MAINE TURNPIKE AUTHORITY

ADDENDUM NO. 2

CONTRACT 2026.01

PAVEMENT REHABILITATION AND
SAFETY IMPROVEMENTS
MM 68.5 TO MM 74.9

ESTIMATED QUANTITIES
& GENERAL NOTES

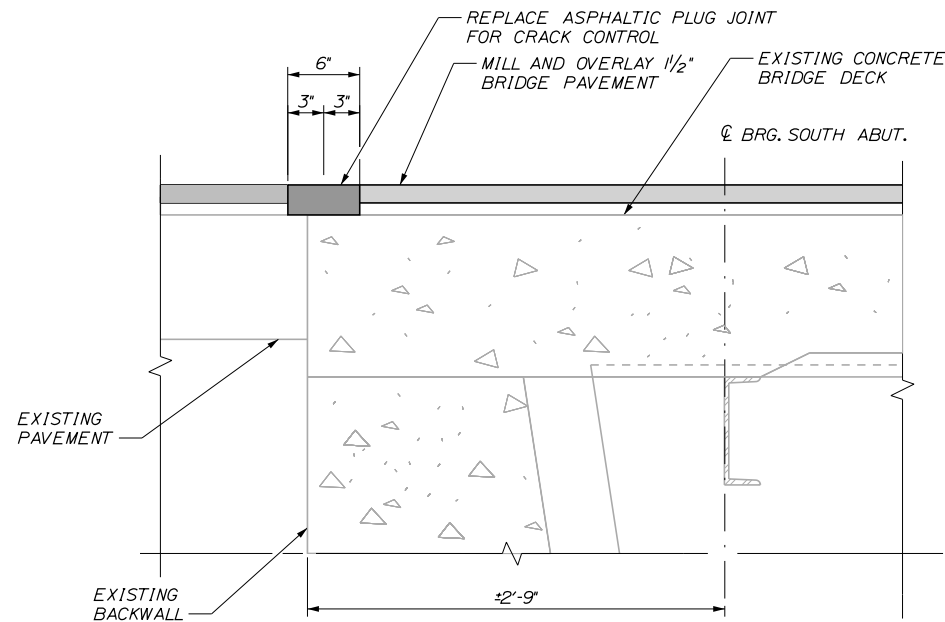
Response: Separate pay items have been added for the milling and paving efforts on Washington and Lisbon Street bridges. See attached Special Provision Sections 202 and 403, Proposal Sheets and Estimated Quantity Sheet Plan associated with Addendum #2.

- The title sheet (sheet 1 of 24) has been updated to reflect the change in project name.
- The estimated quantities & general notes sheet (sheet 2 of 24) has been updated to reflect the additional items.
- The Royal River bridge joint details (sheet 21 and 22 of 24) have been updated to reflect the change in work.

403.208I	HOT MIX ASPHALT - 12.5 MM (POLYMER MODIFIED)	T	25315
403.2080I	HOT MIX ASPHALT - 12.5 MM (POLYMER MODIFIED) - WASHINGTON ST. AND LISBON ST. BRIDGES	T	785

JOINT REPAIRS (SHEET 1 OF 2)

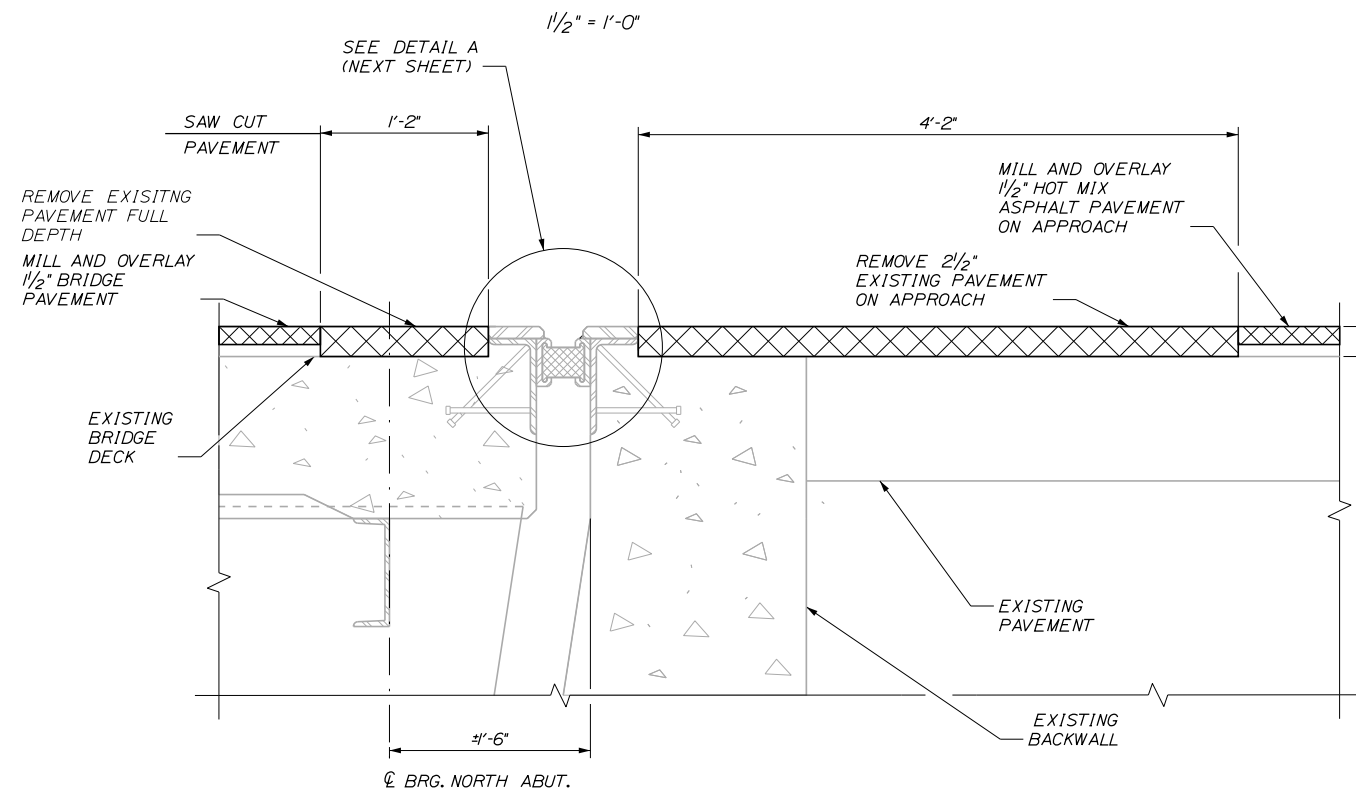
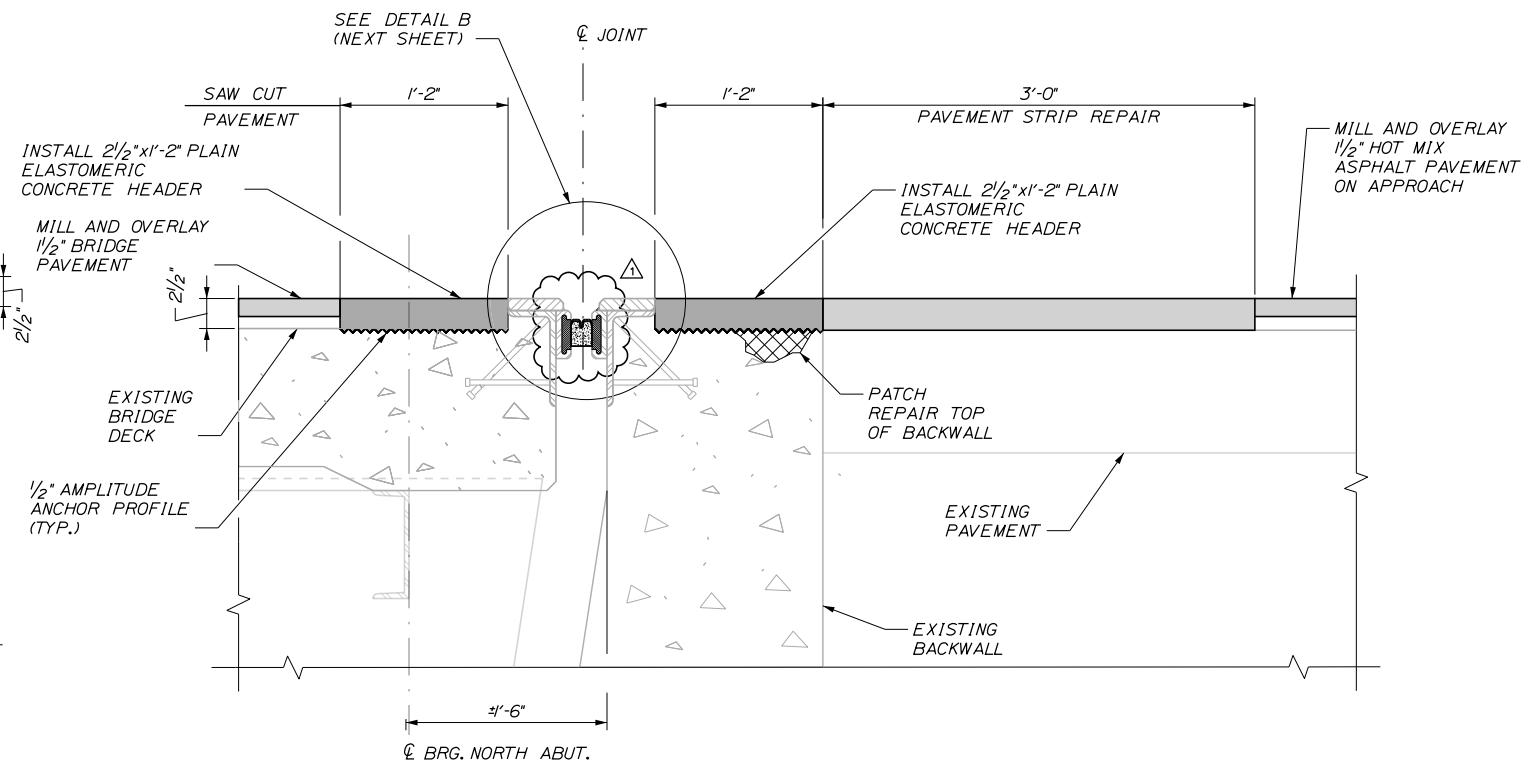
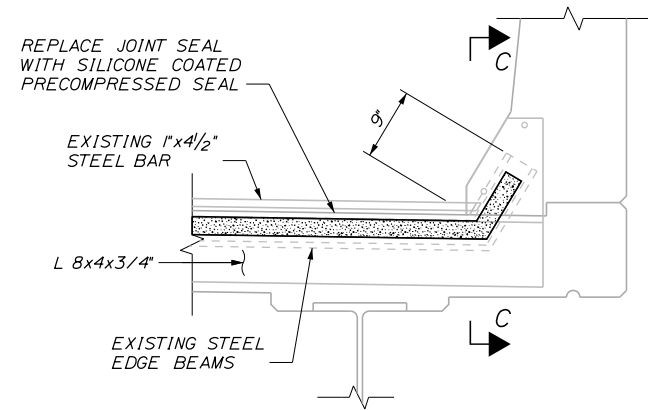
- Special Provision sheets SP-79 through SP-81 have been updated to reflect a change in work associated with repairing bridge joints.
- Special Provision Sheet SP-109 shall be replaced to have section “627.05 Preparation of Surface” updated. The last two sentences of the first paragraph shall now read “The use of Polycrystalline Diamond Compact (PDC) flat cutting head or gang stacked diamond cutting heads with free floating independent heads is required for asphalt pavement

Scale: AS NOTED			
No.	Revision	By	Date
1.	CHANGED JOINT REPAIR DETAIL	DSM	12/25
